UNITED STATES PATENT AND TRADEMARK OFFICE

APPLICATION NO.	FILING DATE	FIRST NAMED INVENTOR	ATTORNEY DOCKET NO.	CONFIRMATION NO.
10/026,961	12/27/2001	Young Hun Ha	8733.524.00	7359
30827	7590	10/08/2004	EXAMINER	
MCKENNA LONG & ALDRIDGE LLP 1900 K STREET, NW WASHINGTON, DC 20006			LANDAU, MATTHEW C	
			ART UNIT	PAPER NUMBER
			2815

Office Action Summary

DETAILED ACTION

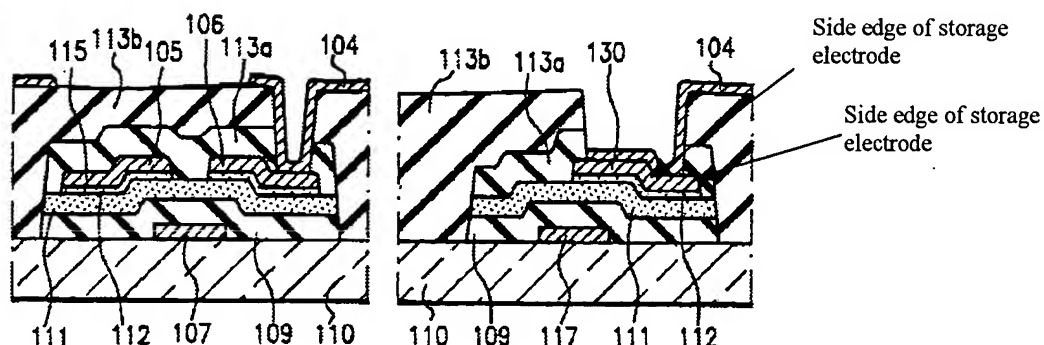
In regards to claim 1, Figures 4 and 5I of Han disclose a liquid crystal display device including a data line 115 supplied with a data signal, a gate lines 117 supplied with a scanning signal, a pixel electrode 104 for driving a liquid crystal cell, and a thin film transistor for responding to the scanning signal to switch the data signal to the pixel electrode, the device comprising: a storage electrode 130 overlapping with the gate line to form a storage capacitor; a first protective layer 113a being formed between the storage electrode and the pixel electrode at a portion of an overlapping area between the storage electrode and the pixel electrode (portion over the right side of the storage electrode, as shown in Figure 5I), wherein the storage electrode is directly connected to the pixel electrode at an end of the overlapping area (Figure 5I); and a second protective layer 113a formed between a gate insulating film 109 and the pixel electrode.

In regards to claim 2, Figure 5I of Han discloses the gate insulating film 109 on a substrate 110 in such a manner to cover the gate line; and a first semiconductor layer 111/112 between the gate insulating film and the storage electrode.

In regards to claim 6, Figures 4 and 5I of Han disclose a liquid crystal display device including a data line 115 supplied with a data signal, a gate lines 117 supplied with a scanning signal, a pixel electrode 104 for driving a liquid crystal cell, and a thin film transistor for responding to the scanning signal to switch the data signal to the pixel electrode, the device comprising: a storage electrode 130 overlapping the gate line to form a storage capacitor; and the pixel electrode covering an upper surface and side edges of the storage electrode, wherein the storage electrode is directly connected to the pixel electrode at an end of an overlapping area between the storage electrode and the pixel electrode. A marked-up version of Figure 5I is provided below for clarification.
